Subject: FRONT DOOR INTERFERES REAR DOOR GARNISH	Bulletin No.: 09-007/21
	Last Issued: 02/25/2021

2019-2020 Mazda3 5-door HB (Japan built) with VINS lower than JM1BP*****158118 (produced before November 29, 2019)

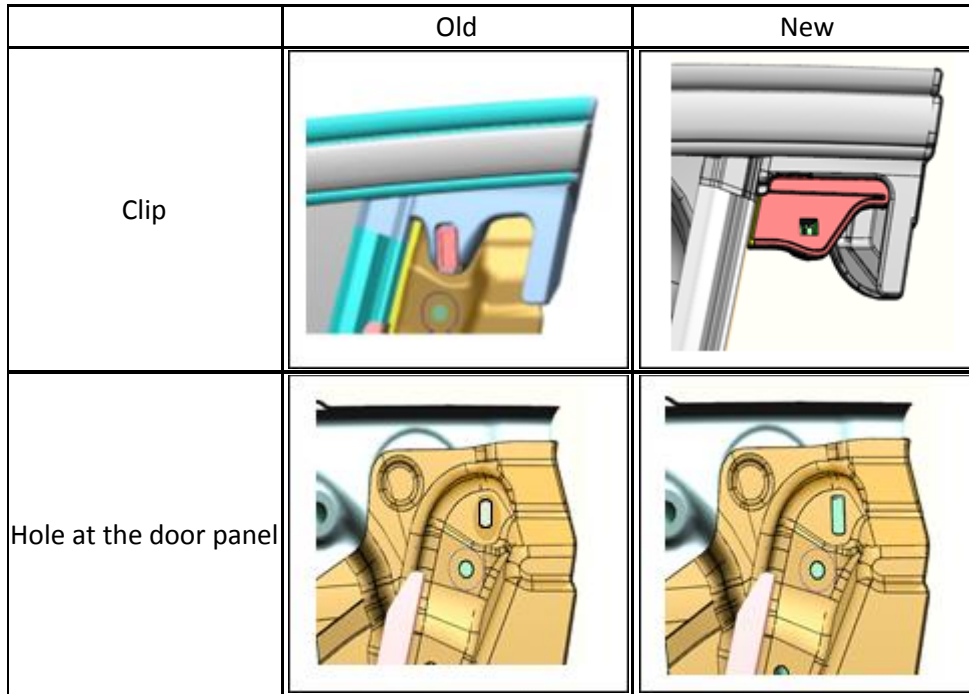
Some vehicles may exhibit that the glass run channel of the front door interferes with the rear door garnish.

Since the front door glass run channel is not fixed to the door strongly enough for the following situations, cycles of door operation may result in interference and lead to damage on the seal rubber at the rear door.

- When the front door glass is closed, the glass run channel may be forced to move to the B pillar side.
- In very hot climates, the glass run channel may expand to the B pillar side.

To eliminate this concern, the following 2 phases have been started as a running change:

- Phase 1
 - Adhesive has been added between the front door glass run channel and the door panel.

- Phase 2
 - The shape of the front door glass run channel has been changed so as not to make contact with the rear garnish.
 - The shape of the clip at the rear side of the front door glass run channel has been changed for stronger fixing and the hole at the door panel has been changed accordingly.
